Technical *data*

CT 939 K2/K3 & CT1120K1 timing belt kit, used for example in:
VW / Audi 2.5 TDI 5 cyl.

**Fig. 1
Washer**

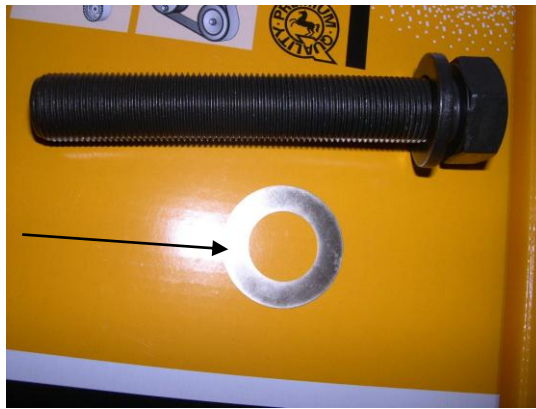
In accordance with the updated equipment status, the timing belt kit contains a thin washer (diamond-coated) that was not previously installed in the vehicle.

According to the VW/Audi catalog, this special washer (4) is to be installed between the crankshaft drive wheel (3) and the torsional vibration damper (5). This is intended to improve the co-efficient of friction.
